Project	IEEE 802.16 Broadband Wireless Access Working Group < http://ieee802.org/16 >	
Title	Performance Management Primitives for Performance Monitoring Procedures	
Date Submitted	2005-09-13	
Source(s)	ZTE corporation	fu.lianxu@zte.com.cn
	Lianxu Fu	kang.honghui@zte.com.cn
	Honghui Kang	xu.ling@zte.com.cn
	Ling Xu	jqian@ztesandiego.com
	Jeff Qian	
	Cancan Huang	
	Ernie Tacsik	
	Xiaolu Dong	
Re:	Contribution on comments to IEEE 802.16g-05/008	
Abstract	In this contribution, we propose to define some primitives for performance monitoring management.	
Purpose	Adoption	
Notice	This document has been prepared to assist IEEE 802.16. It is offered as a basis for discussion and is not binding on the contributing individual(s) or organization(s). The material in this document is subject to change in form and content after further study. The contributor(s) reserve(s) the right to add, amend or withdraw material contained herein.

Performance management primitives for Performance Monitoring Procedures

3. Proposed Text Changes

Figure 1 Example of primitive flow of Performance monitoring

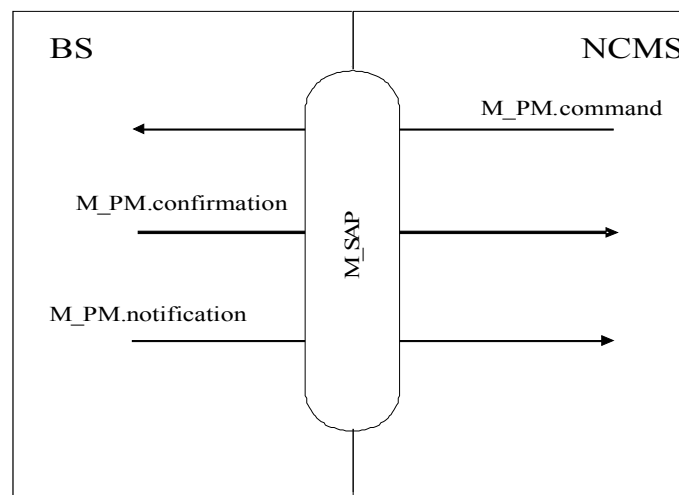
As shown in Figure 1, the procedure is as the following:

[Insert section 14.5.4 as follow]

Figure 306a shows the example of performance monitoring procedure

Figure 306a Example of primitive flow of Performance monitoring
